Research Report 1524

MANPRINT Evaluation: AN/TRC-170 Digital Troposcatter Radio System

Gregory S. Krohn and Samuel E. Bowser
Essex Corporation

June 1989

Figure 18. An example of the type of manipulation task that could be performed more rapidly by crewmen using a stepladder or platform.

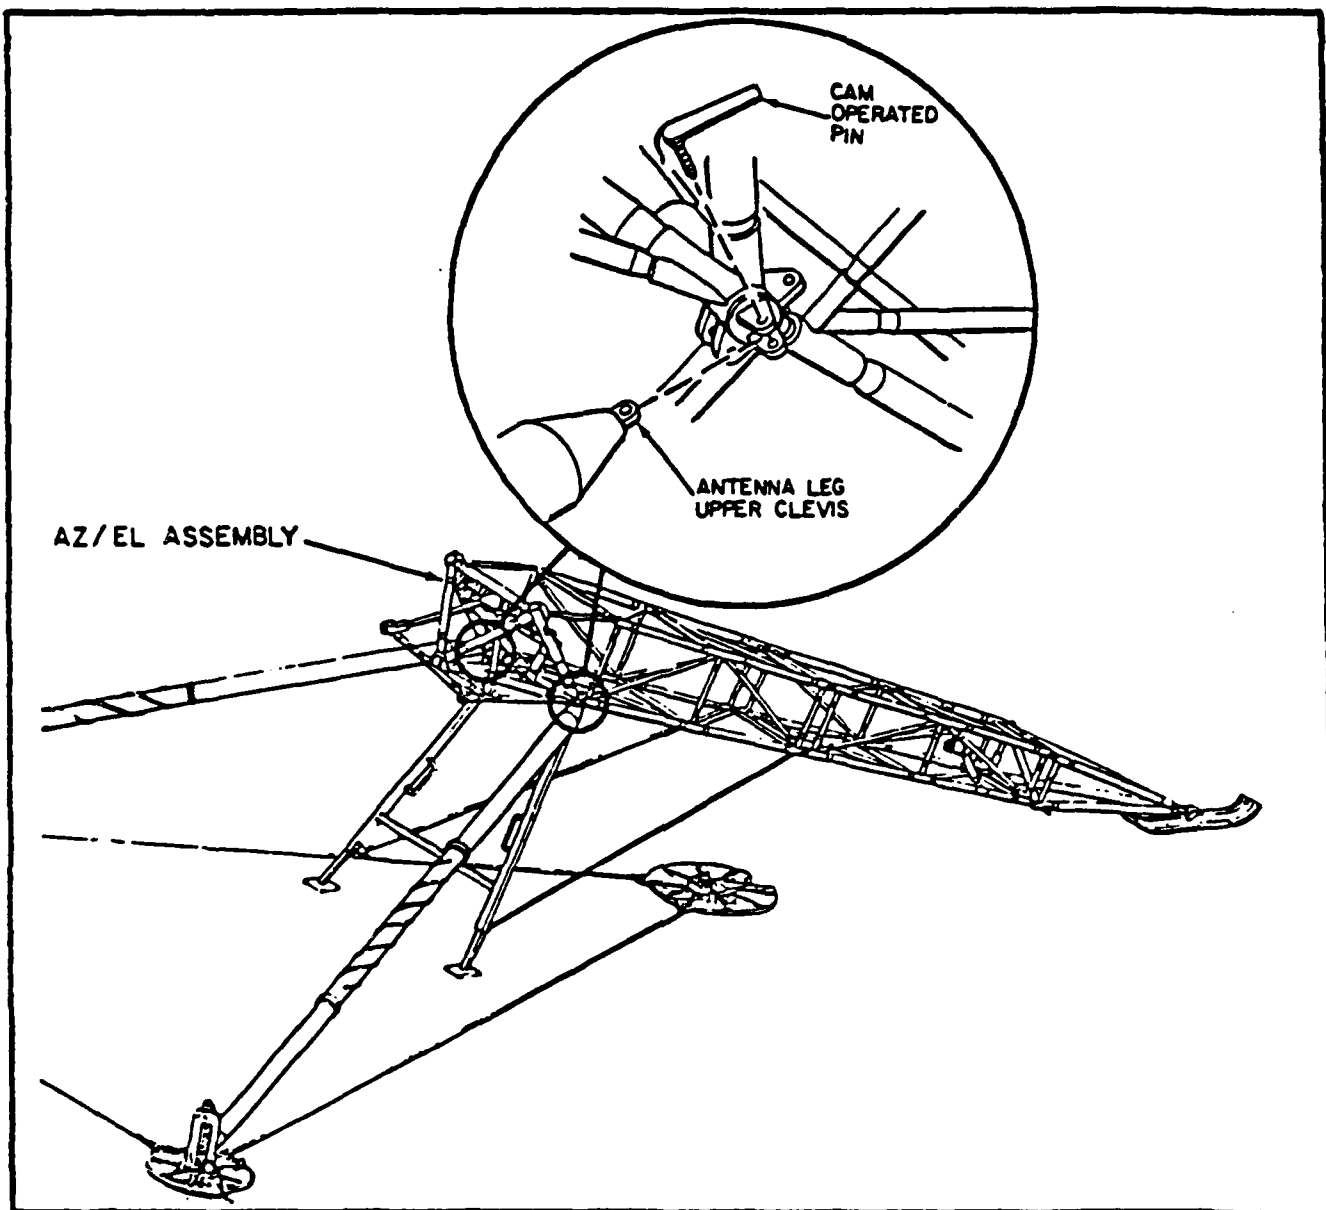
Description of the Problem: Figure 18 shows the type of manipulation task that must be performed on the 9.5-ft antenna. Figure 19 shows the antenna hand crank that is difficult to reach. The assembly of the 9.5-ft antenna has several situations where personnel need to extend their reach. There is no ladder or other approved stand available on the AN/TRC-170. The situations include the following:

Potential Solutions: Provide a stand as standard equipment issue for the AN/TRC-170(V2). It is recommended that at least a 3-ft high stand or ladder be supplied.

Figure 20. The interior of the low-profile pallet showing the location of the accessory alignment kit.

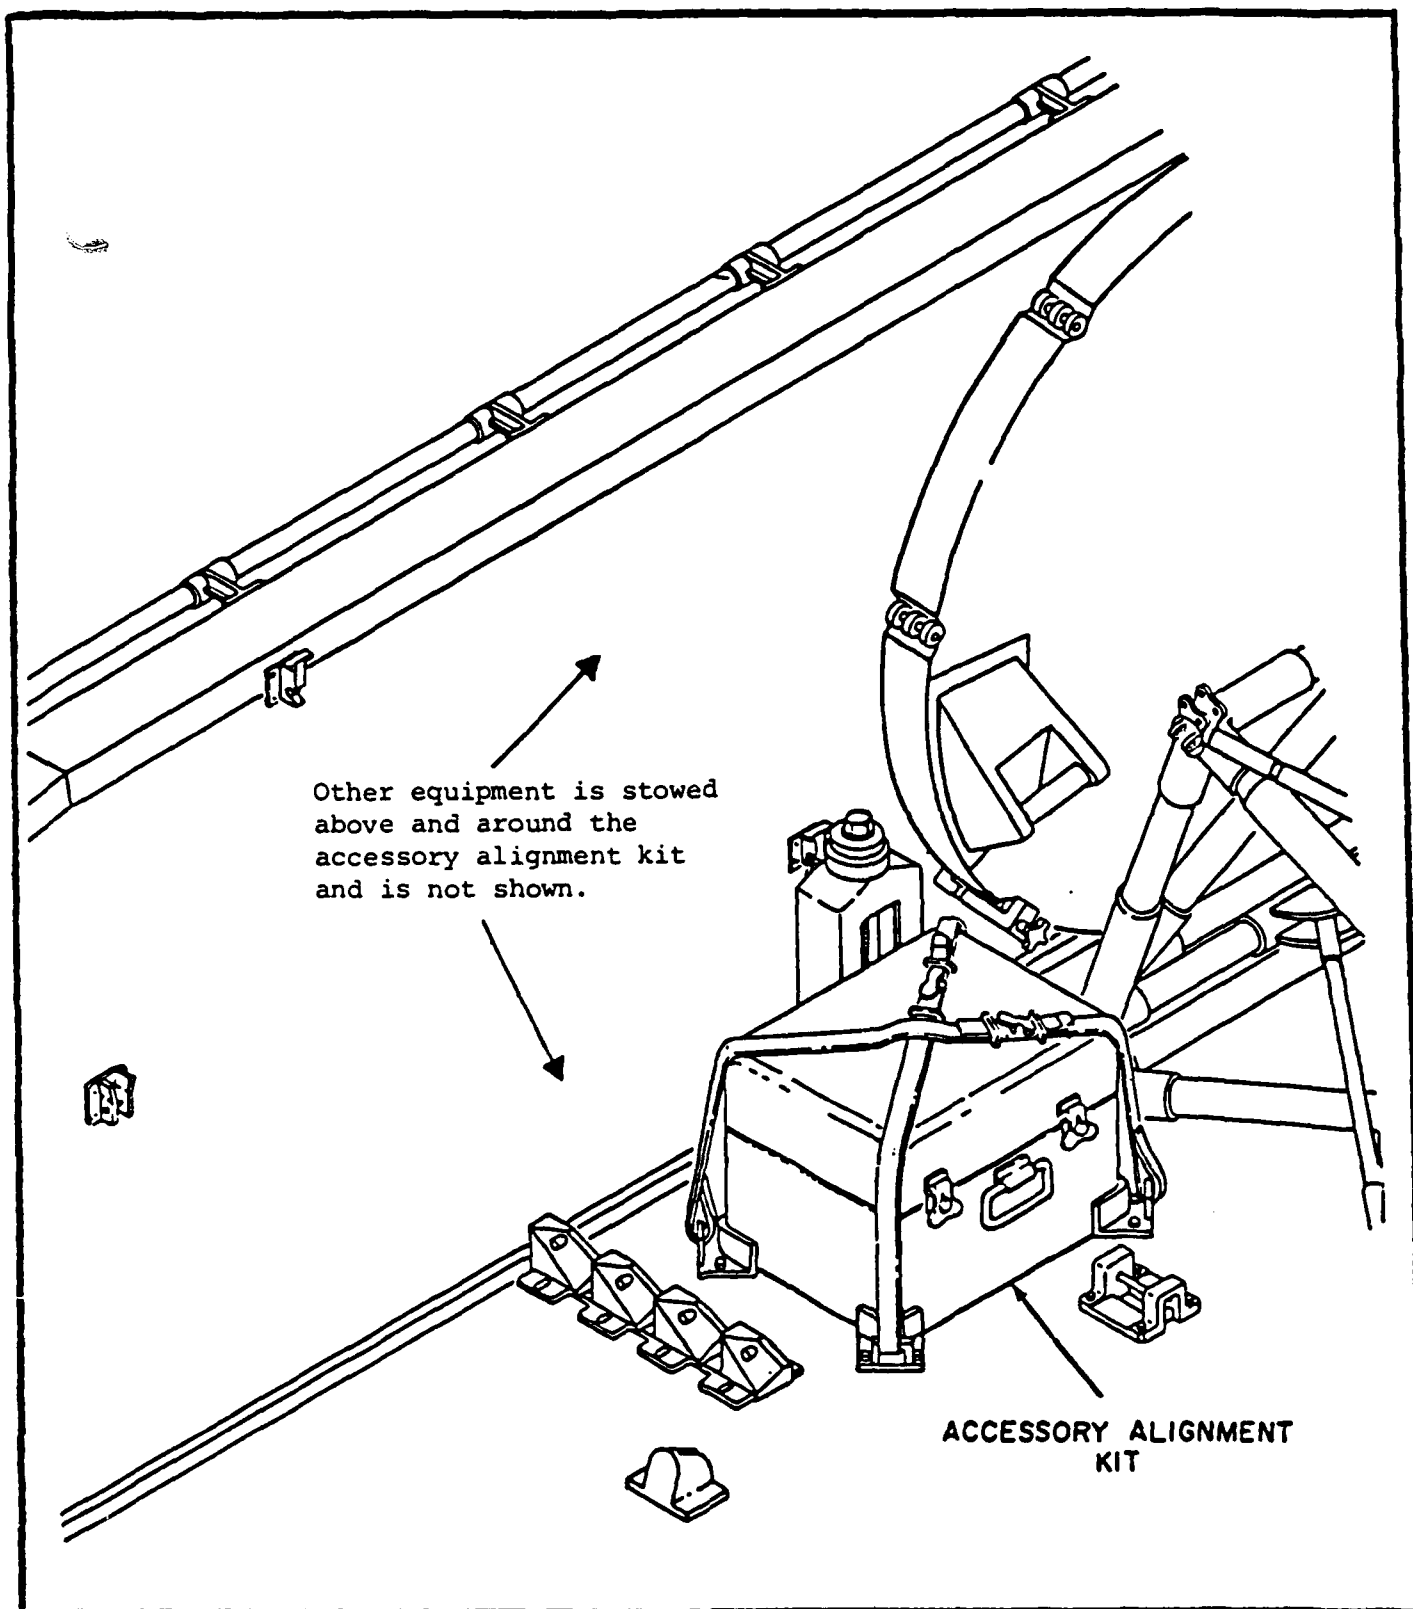
Description of the Problem: Figure 20 shows the location of the accessory kit on the low-profile pallet. The location of the accessory kit, which includes the pocket transit on the low-profile pallet, is located on the bottom of the pallet beneath the antenna truss structures. The pocket transit is the first item needed for site layout. The crew must remove the canvas cover from the pallet and push antenna parts out of the way to retrieve the kit.

Potential Solutions: The accessory kit should be placed in the shelter near the door or in the truck cab area for easy access.

Figure 21. The low-profile pallet which was mounted on a 2.5-ton truck.

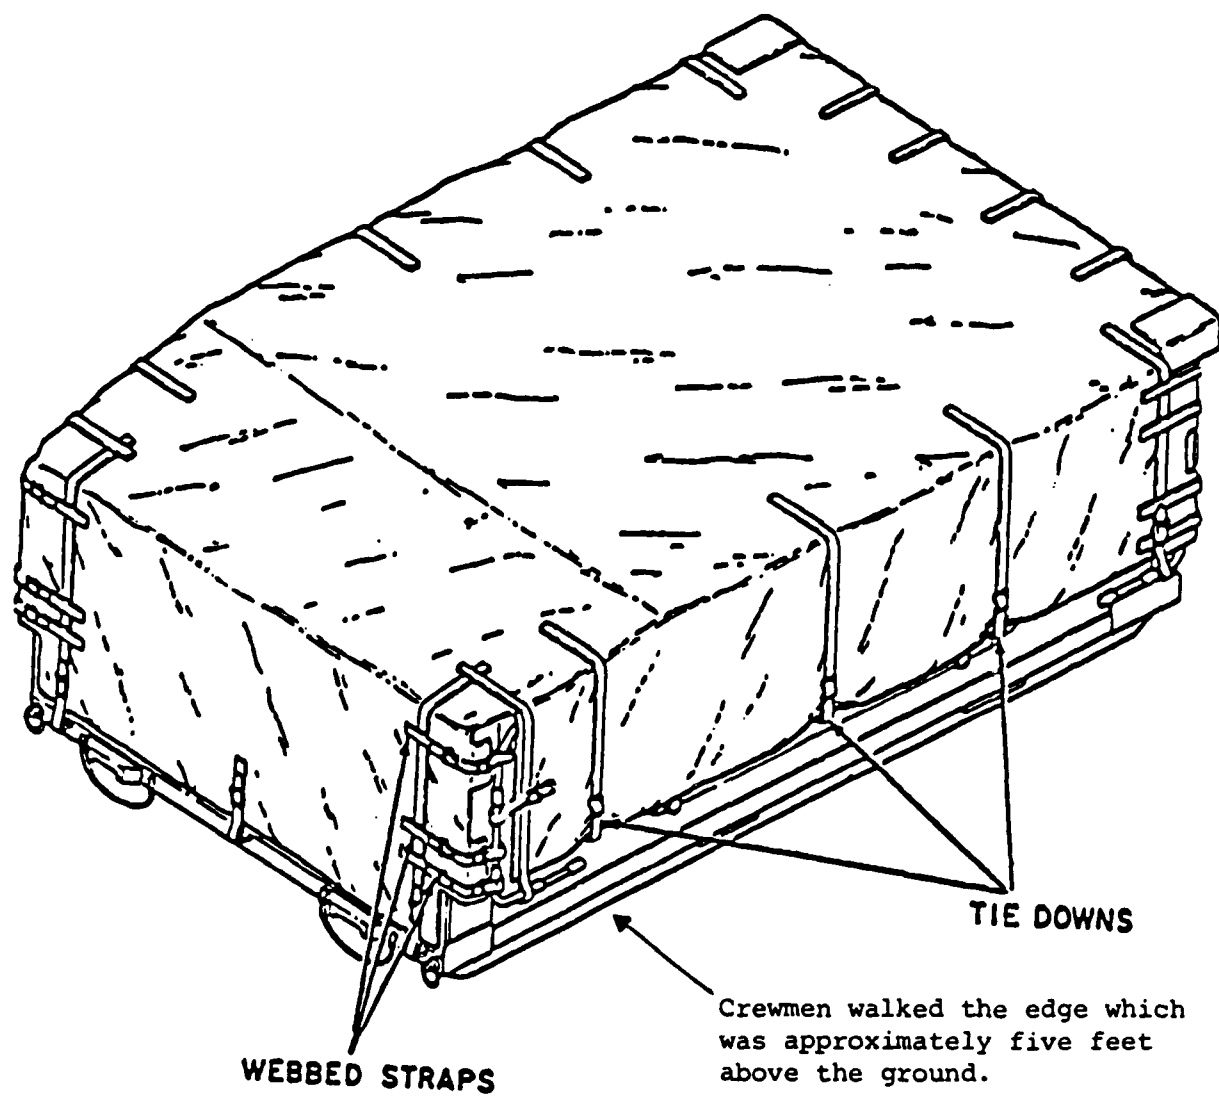
Description of the Problem: Figure 21 shows the low-profile pallet secured for transport. Crewmen must walk on the outside edge (3-in width) of the low-profile pallet in order to remove the canvas and ropes. Crew members must assume unsafe positions when removing the canvas cover and retrieving the accessory kit.

Potential Solutions: The canvas cover over the low-profile pallet could be provided with a drawstring arrangement so that personnel would not have to climb the side of the truck. The load on the low-profile pallet should be redistributed to facilitate loading and unloading, and consideration should be given to moving some of the load to the shelter.
